CITY OF ST. PETERSBURG, FLORIDA
PLANNING AND DEVELOPMENT SERVICES DEPARTMENT
URBAN PLANNING AND HISTORIC PRESERVATION DIVISION

STAFF REPORT

Community Planning and Preservation Commission Certificate of Appropriateness Request

AGENDA ITEM:	CITY FILE NO.: 20-90200121
REQUEST:	Review of an After-the-Fact Certificate of Appropriateness application for the replacement of original wood sash windows with vinyl impact windows at a contributing property to a local historic district
OWNERS:	Todd K. Letzring Lori Elizabeth Letzring
PARCEL ID NO.:	23-31-16-35118-008-0090
ADDRESS:	2949 3 rd Ave. N.
LEGAL DESCRIPTION:	HALL'S CENTRAL AVE NO. 2 BLK 8, E ½ OR VILLA SITE 9
ZONING:	NT-2

Part 4 ext. Left to right

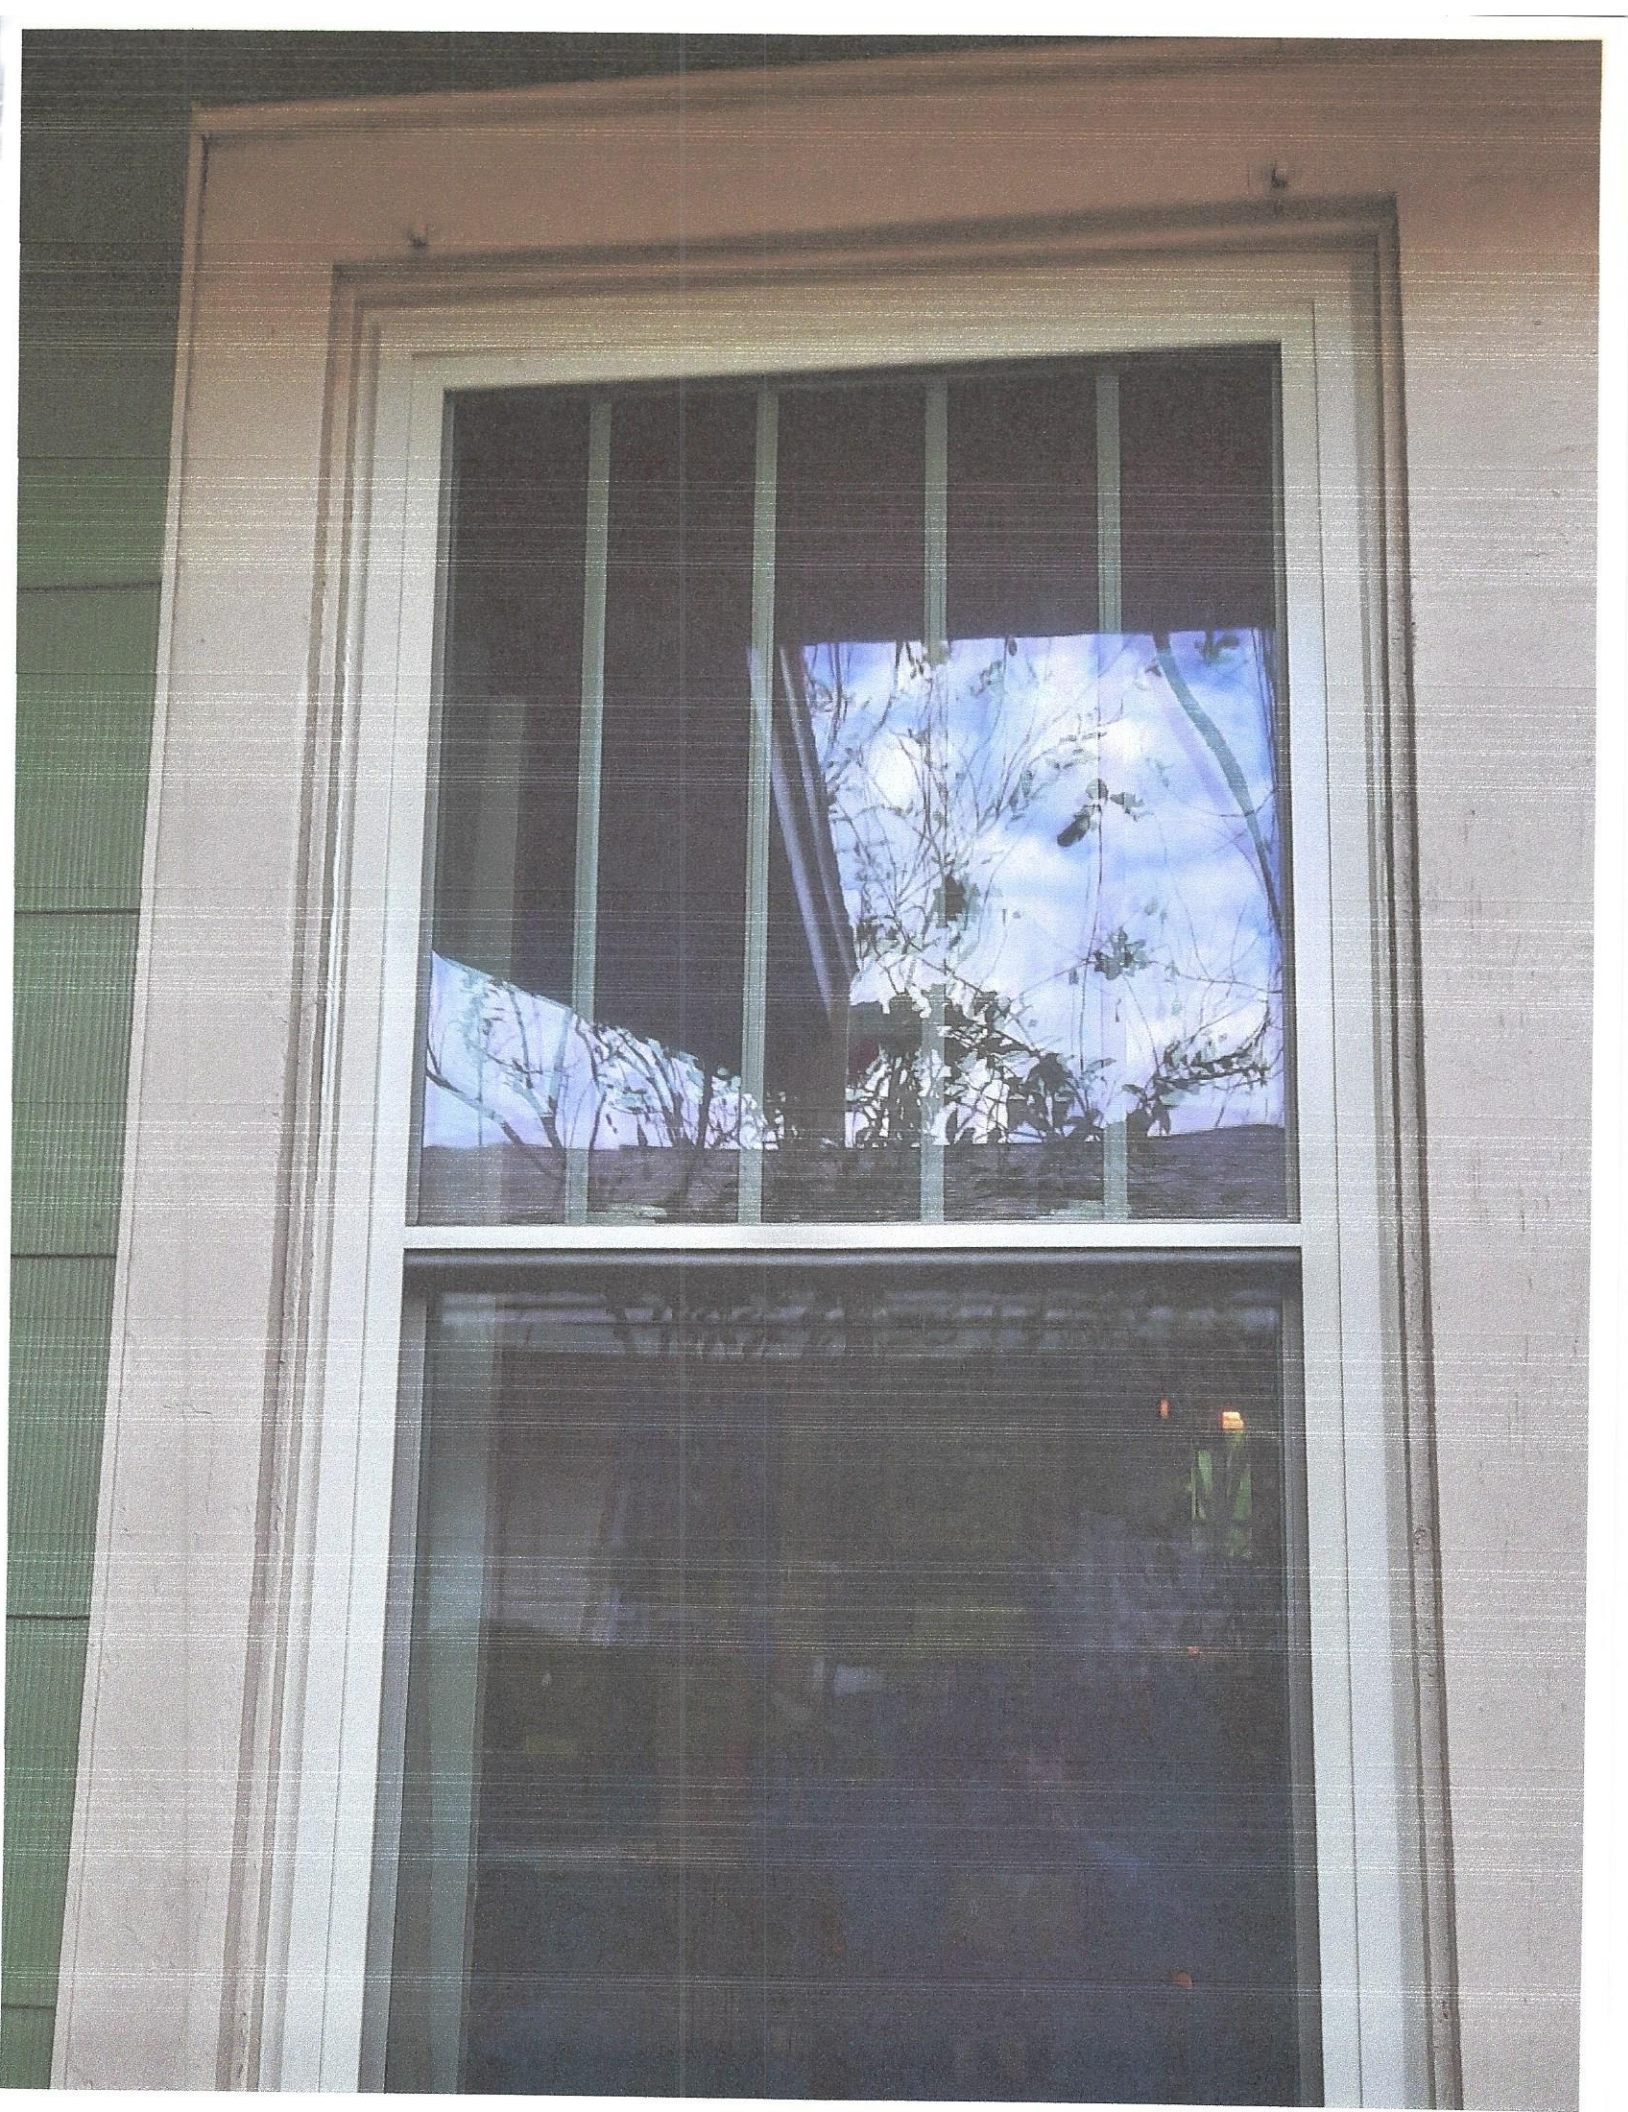
Currently the replacement windows feature only internal muntins. Staff suggests that approval of this application be conditioned upon installation of contoured, external muntins to more closely replicate the historic windows' texture.

Partially consistent Staff suggests that contoured, external muntins be required to be applied to the replacement windows to increase their compatibility

1. Replacement windows will be fitted with contoured, three-dimensional external muntins.
2. All other necessary permits shall be obtained. Any additional work shall be presented to staff for determination of the necessity of additional COA approval.
3. This approval will be valid for 24 months beginning on the date of revocation of the local Emergency Declaration.
4. A historic preservation final inspection will be required.
